## **Proposed Kariong Sand and Soil Supplies Facility – SSD866o**

Water Cycle Impact Assessment  
and Soil and Water Management  
Plan

Response to Submissions:  
Supplementary Report A  
Prepared for: Kariong Sand and  
Soil Supplies

December 2020  
Project No. 197

PROJECT: PROPOSED KARIONG SAND & SOIL SUPPLIES FACILITY - SSD8660	
CIVIL WORKS PLAN	
CLIENT:	KARIONG SAND & SOIL SUPPLIES
JOB REF No:	197

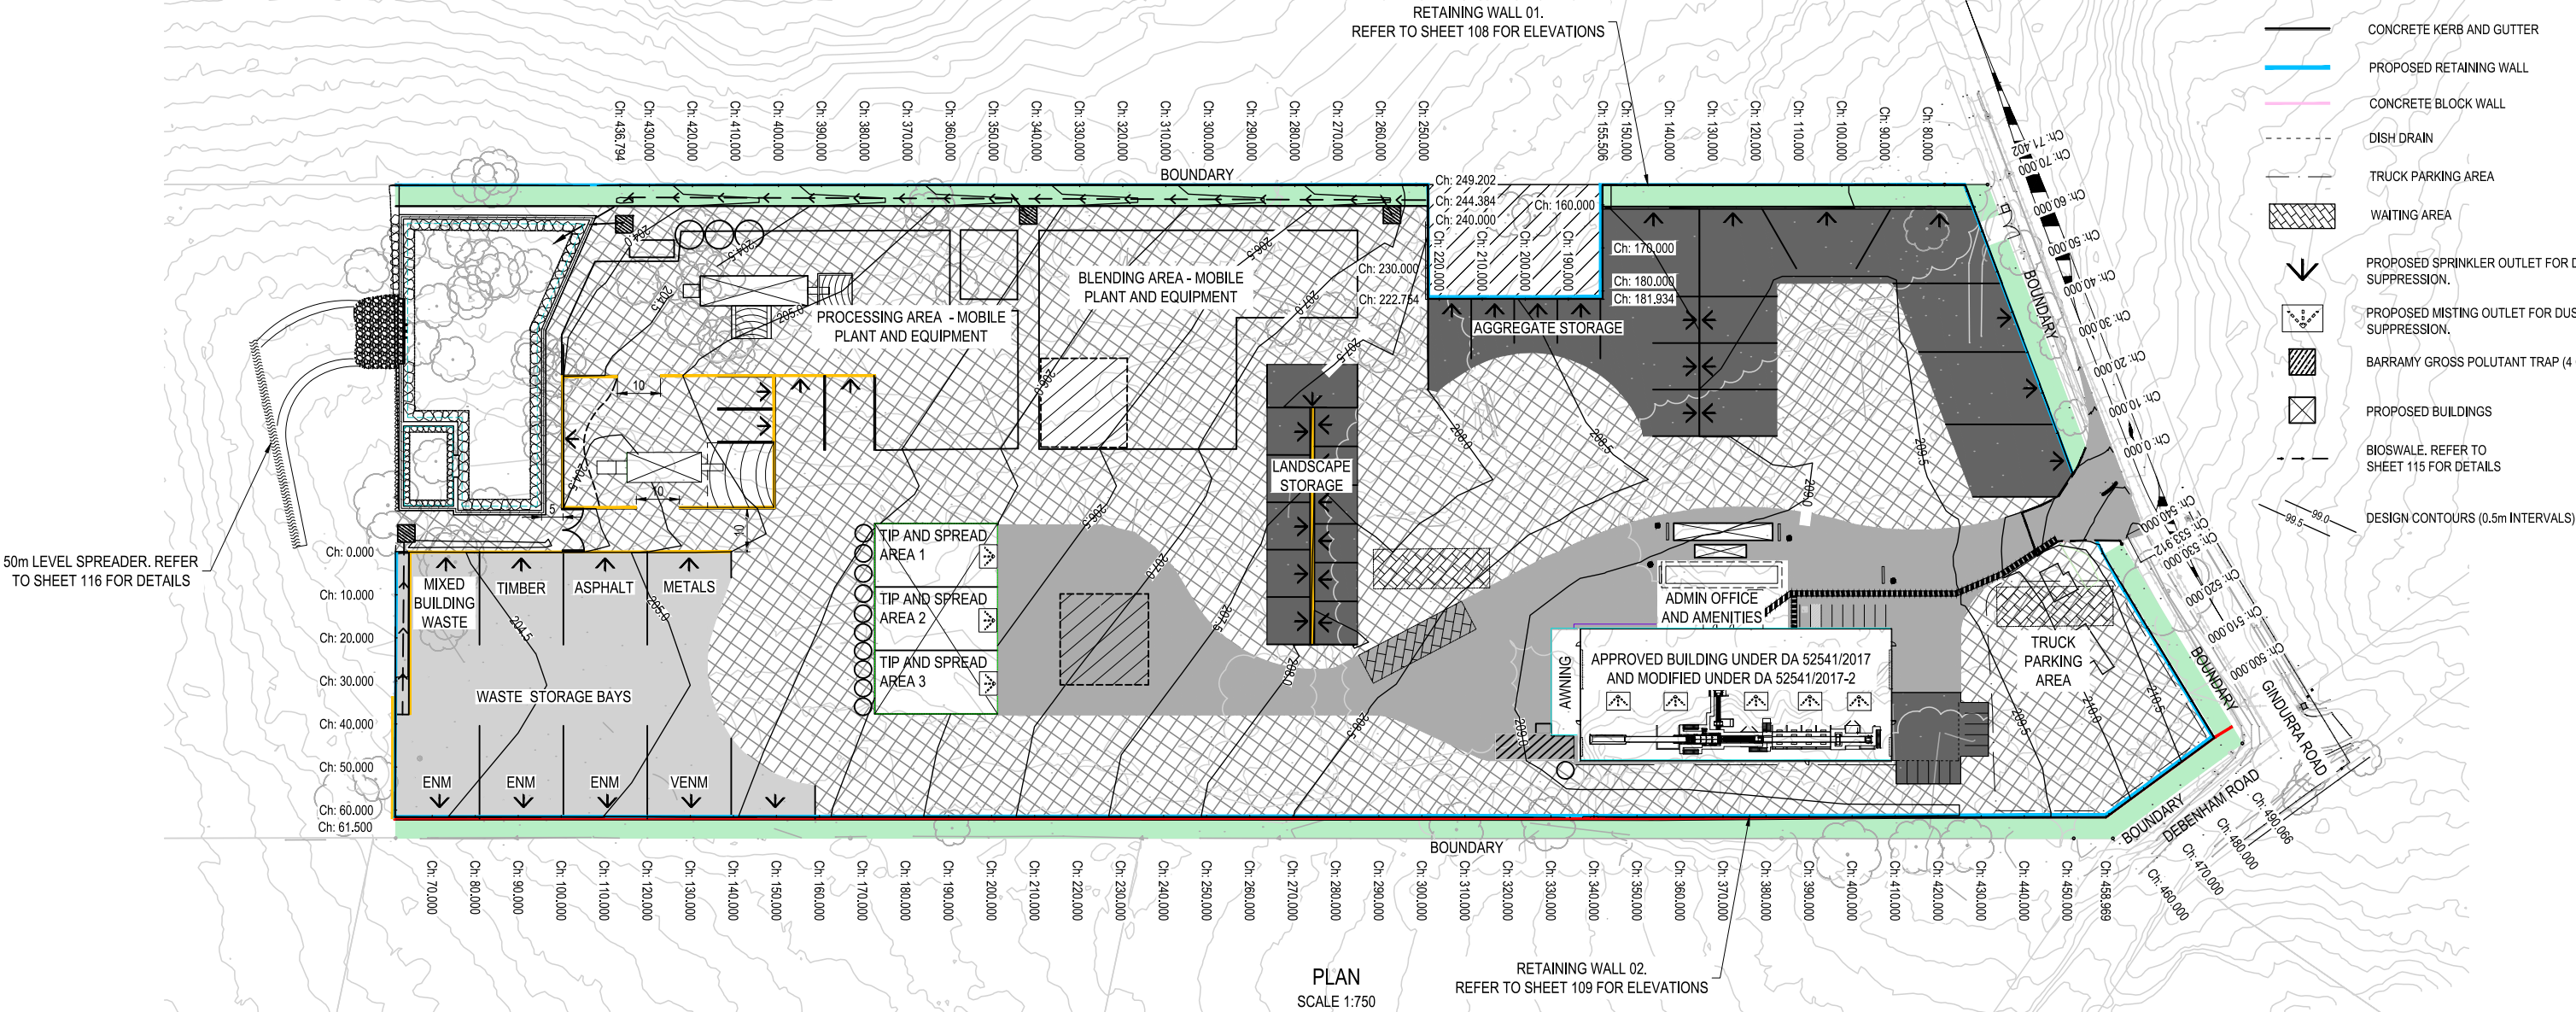
The Applicant has amended the proposal to now include fully enclosed buildings and bunkers around both the crusher and mulcher operations.

- 1) The addition of a pump to enable the pond to function as a Type D sediment retention pond whereby water that is compliant with agreed discharge requirements will be discharged from the pond in a controlled manner when feasible.
- 2) The addition of bunkers around the mulcher and crusher.

5	10/12/2020	REVISED FOR DA - CRUSHER AND MULCHER BUILDING CHANGED	ML	ML
4	07/04/2020	REVISED FOR DA	AB	ML
3	27/03/2020	REVISED FOR DA	GA	ML
2	20/01/2020	FOR DA	GA	ML
REV	DATE	DESCRIPTION	BY	CKD

STORMWATER PLAN

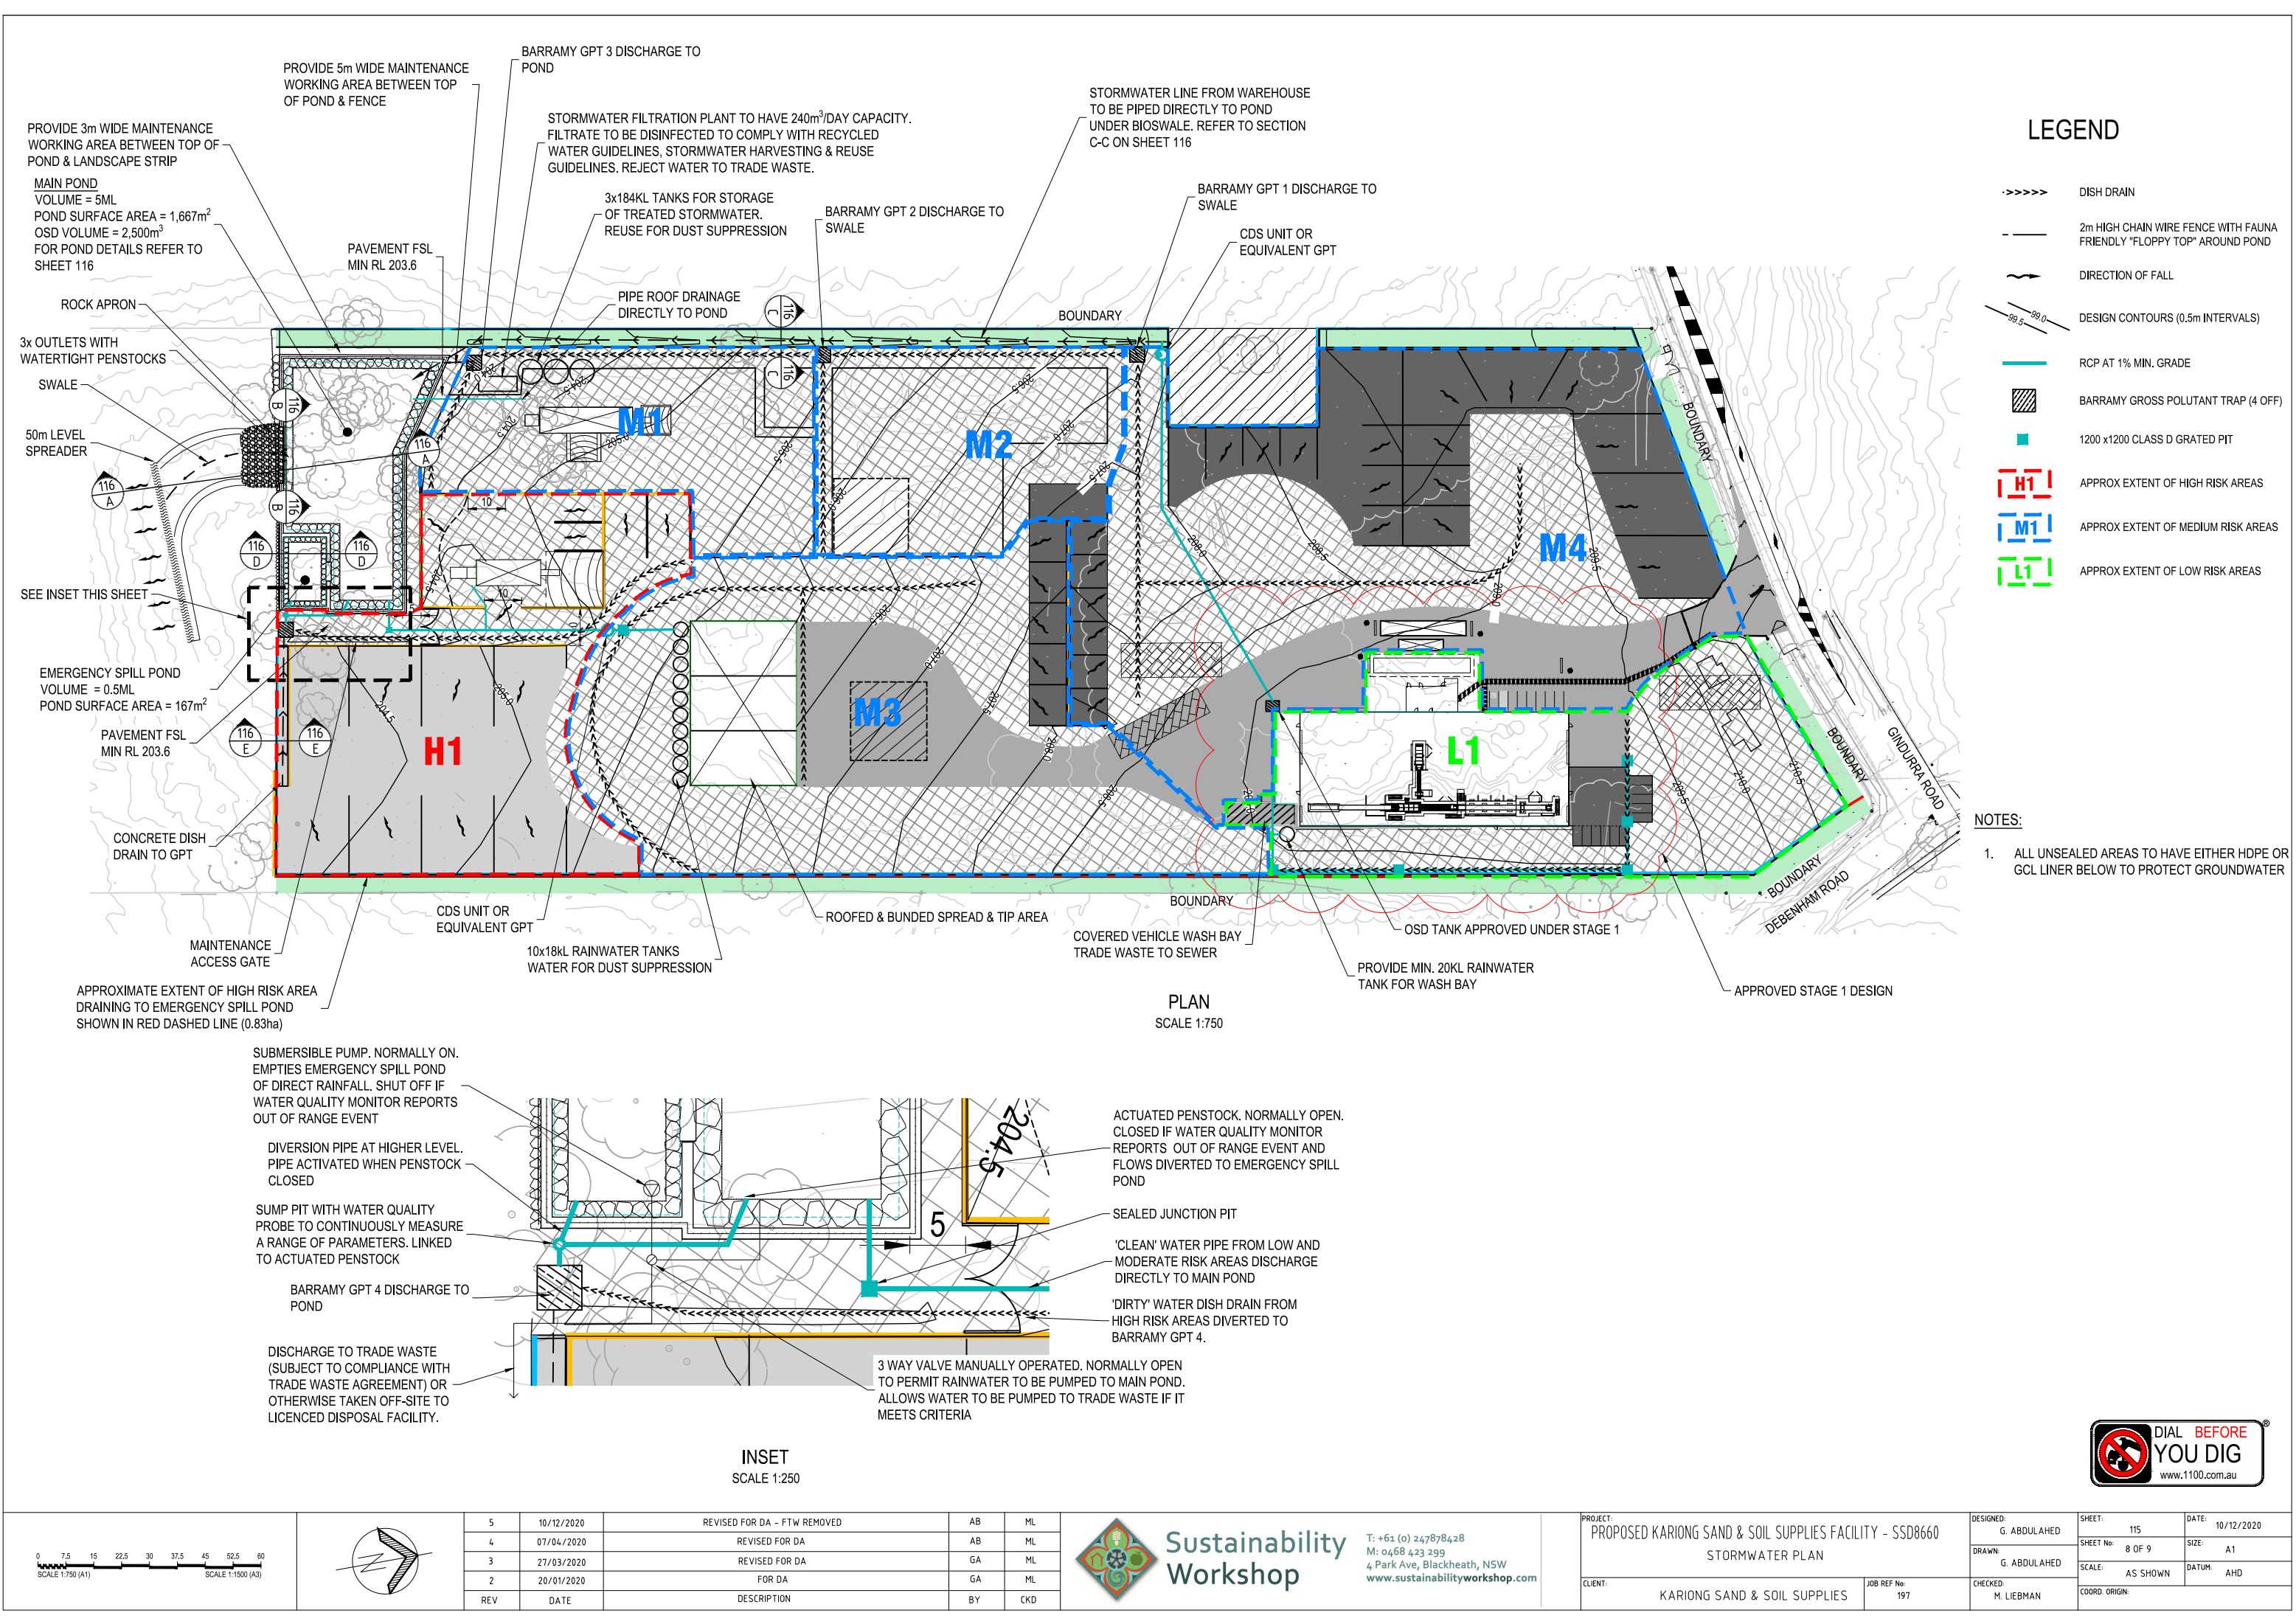
- 1) The Floating Treatment Wetland has been removed from the proposal
- 2) The proposed 5,000 m<sup>3</sup> storage pond will be operated with a 5 day trigger to discharge meaning that it will discharge treated water to the environment under controlled conditions once water quality criteria have been achieved to reduce the frequency of predicted uncontrolled discharges. This is explained further in this report.
- 3) Both the crusher and mulching operations will be fully enclosed within a building.

5	10/12/2020	REVISED FOR DA - FTW REMOVED	AB	ML
4	07/04/2020	REVISED FOR DA	AB	ML
3	27/03/2020	REVISED FOR DA	GA	ML
2	20/01/2020	FOR DA	GA	ML
REV	DATE	DESCRIPTION	BY	CKD
